**METROPOLITAN GOVERNMENT OF NASHVILLE AND DAVIDSON COUNTY**

**STAFF RECOMMENDATION**  
**1000 Paris Avenue**  
**August 21, 2019**

**Application:** Violation; New Construction—Addition  
**District:** Waverly-Belmont Neighborhood Conservation Zoning Overlay  
**Council District:** 07  
**Base Zoning:** R8  
**Map and Parcel Number:** 11801022900  
**Applicant:** Larry Swoopes, Owner  
**Project Lead:** Sean Alexander, sean.alexander@nashville.gov

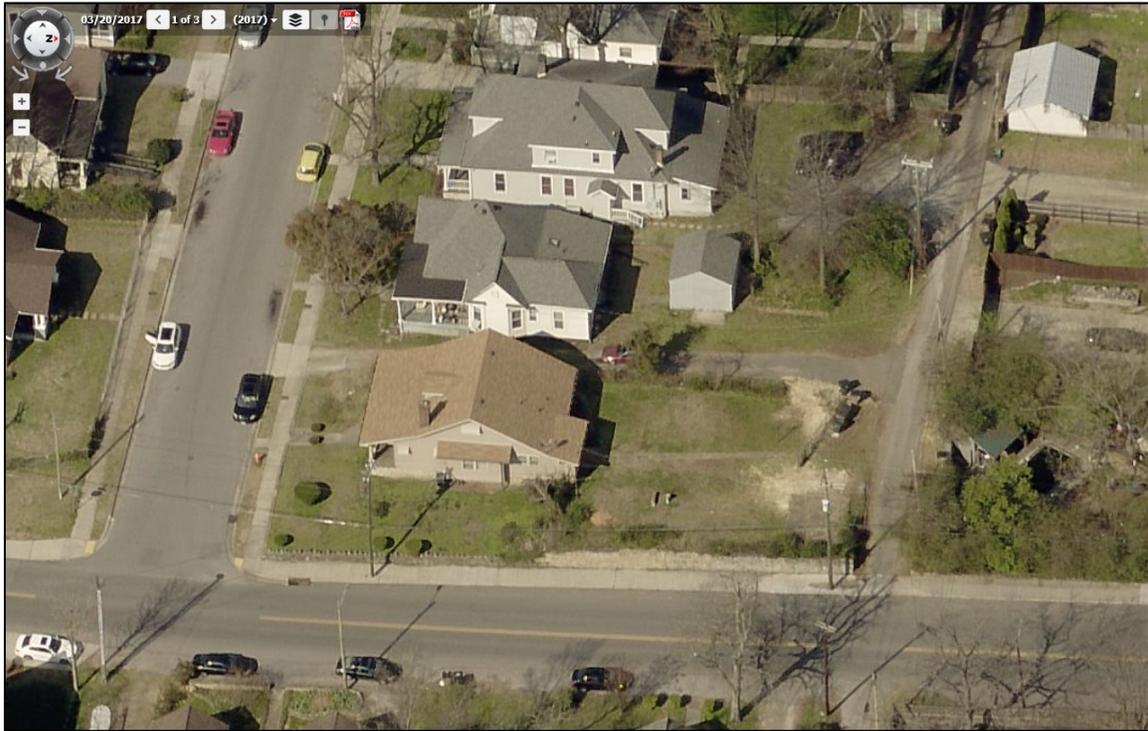
As the construction was nearing completion in March of 2018, Staff observed that a pergola had been constructed between the house and the outbuilding but not attached to either building. Because the structure was freestanding and did not have enclosed sides or a roof, Staff determined after-the-fact that the pergola did not need to be reviewed.

On June 13<sup>th</sup> of this year, MHZC Staff observed that the pergola was in the process of being converted into a permanent enclosed addition with a gabled roof and solid walls with windows and doors. No Preservation Permit or Building Permits have been issued for this work.

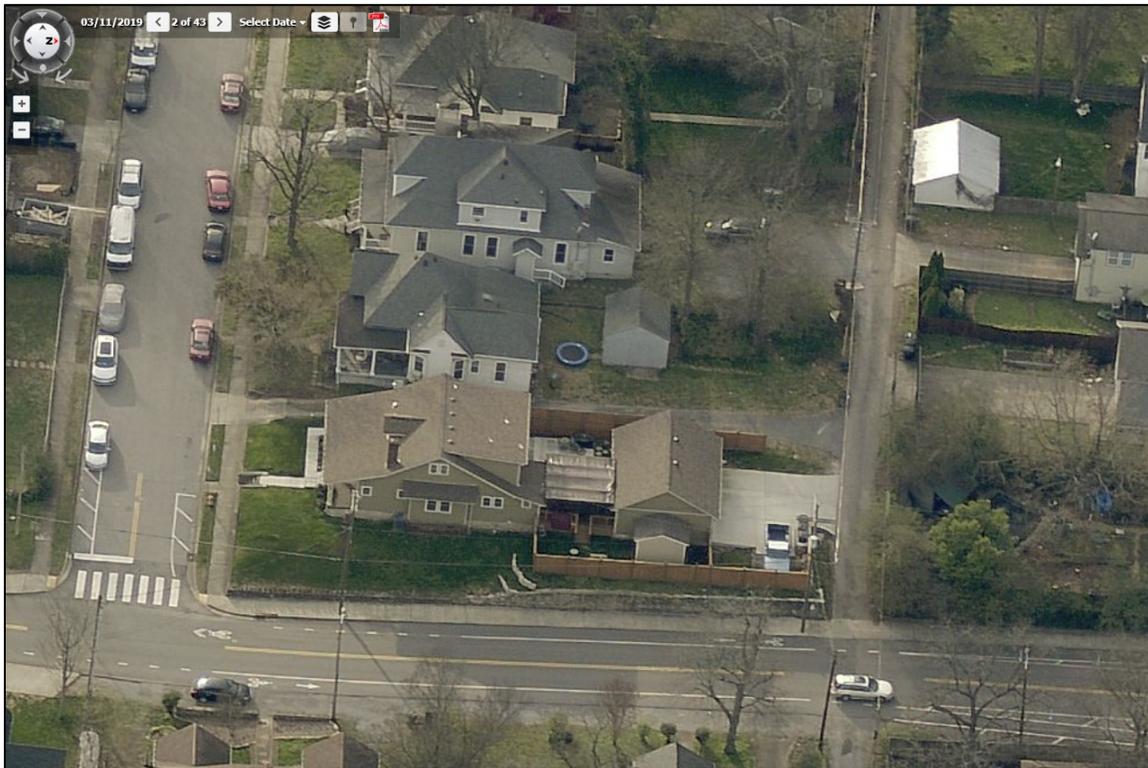
Aerial view from March 2017, before construction of addition and outbuilding.

Aerial view from March 2019, showing rear dormer addition, outbuilding, and pergola.

Drawings Submitted for July 2019 MHZC Review

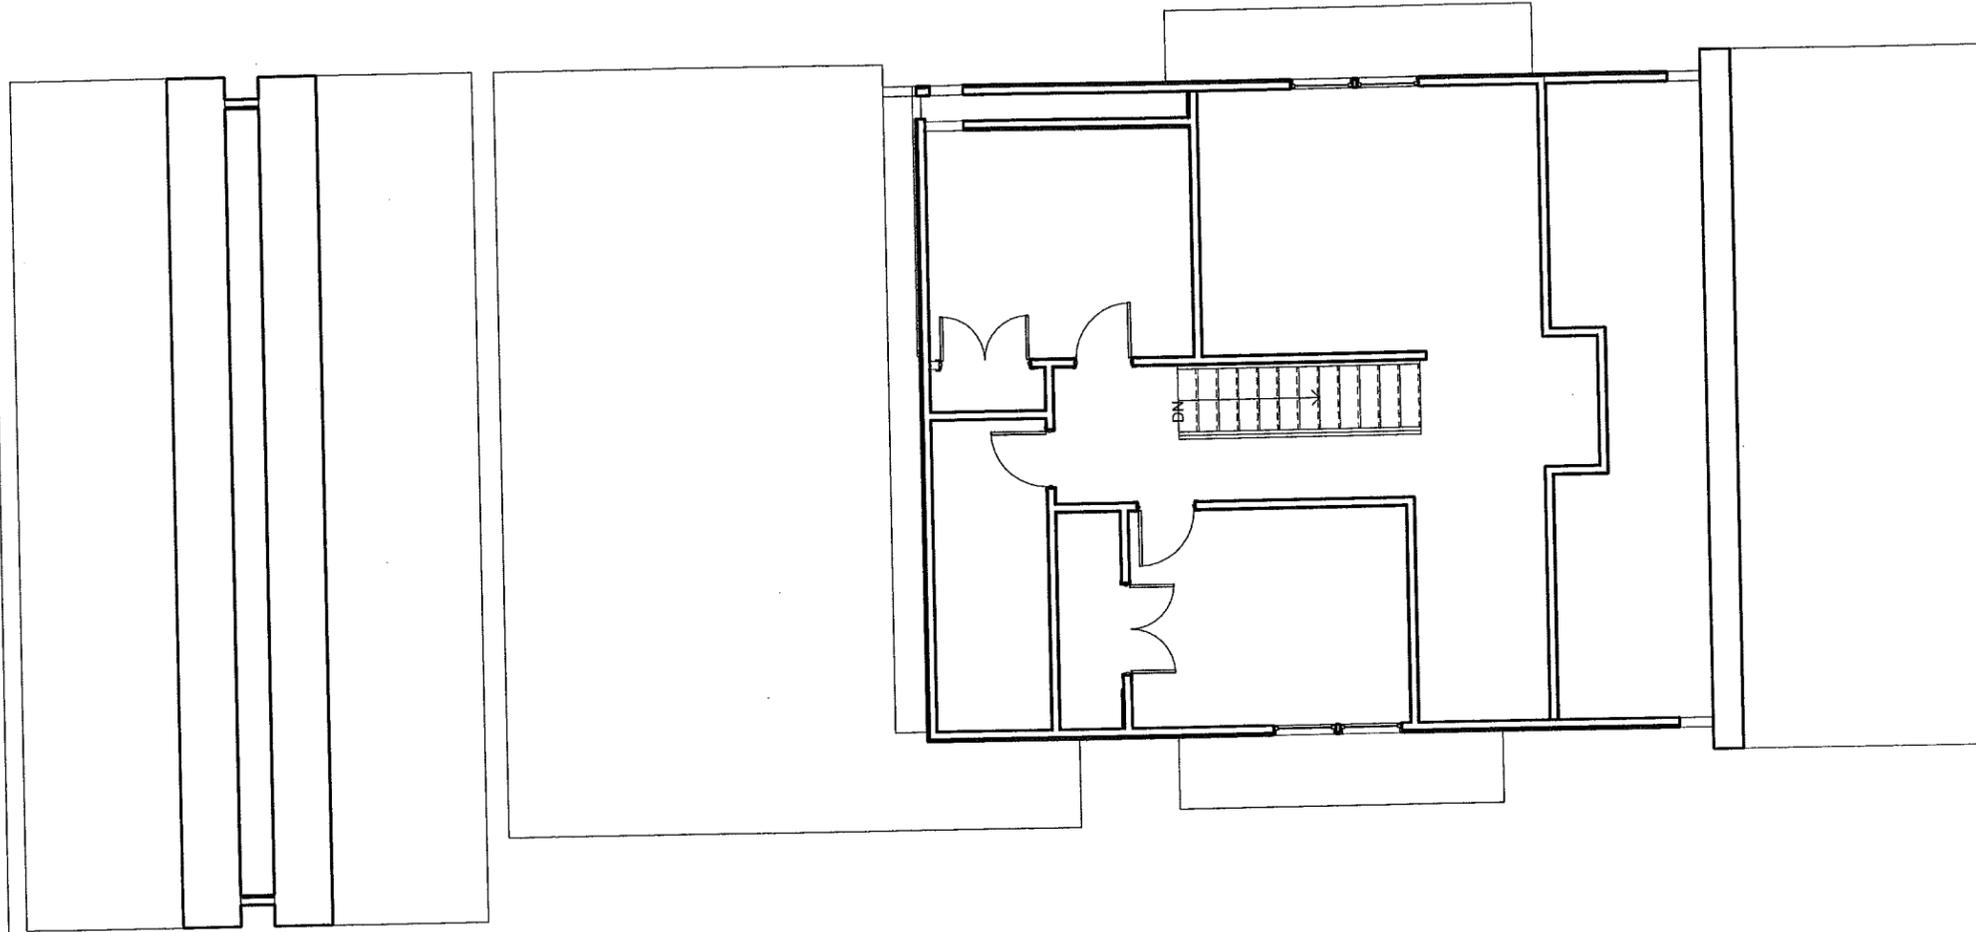
(Note - The plans submitted by the applicant after-the-fact are not accurate, so they were not relied on to determine height and scale.)

(Note - Plans submitted by the applicant after-the-fact are not accurate, so they were not relied on to determine roof form or pitch.)
